LAND USE APPLICATION - COMPLETENESS REVIEW

Subject Property:	3170 Market Street NE
Reference Number:	24-115780-PLN
Application Type:	Class 2 Site Plan Review
Date Application Accepted:	July 25, 2024
Applicant:	Adnan Kamati adnan@kbtengineers.com
Contact:	Same as applicant

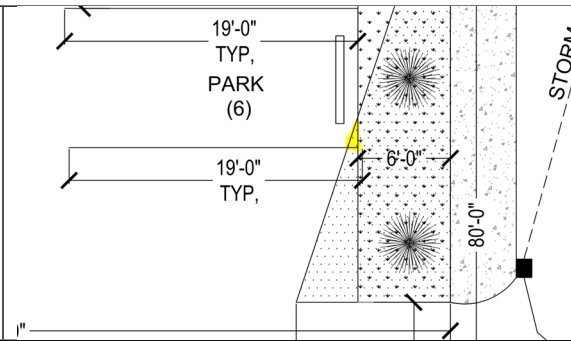
Access onto Arterial Streets *Adjustment not Supported	SRC 804.035(c)(2) requires access be taken from the lower classification street for corner lots abutting an arterial street and lower classification street. The applicant is advised that if access onto Market Street NE is requested, an adjustment to this standard would be required. Staff is not supportive of allowing an adjustment to this standard and recommends all accesses onto Market Street NE be permanently closed. The Market Street driveway approach also does not meet the spacing standard required for access onto an arterial street, which is 370-feet from adjacent intersections and driveway approaches (SRC 804.035(d)).	Existing Conditions Plan need to show existing driveway width to determine if they are being modified.
Chapter 805 – Vision Clearance		
Vision Clearance Obstructions *Adjustment not Supported	The proposed parking does not meet vision clearance standards established in SRC 805.005. The applicant is advised to revise the plans to meet the vision clearance standards in SRC Chapter 805.005. New Comments based on revised submittal: Please note that any vegetation within the vision clearance area will be required to be less than 30-inches in height (SRC 805.010)	Not addressed – Parking along Savage appears to be within the vision clearance area.
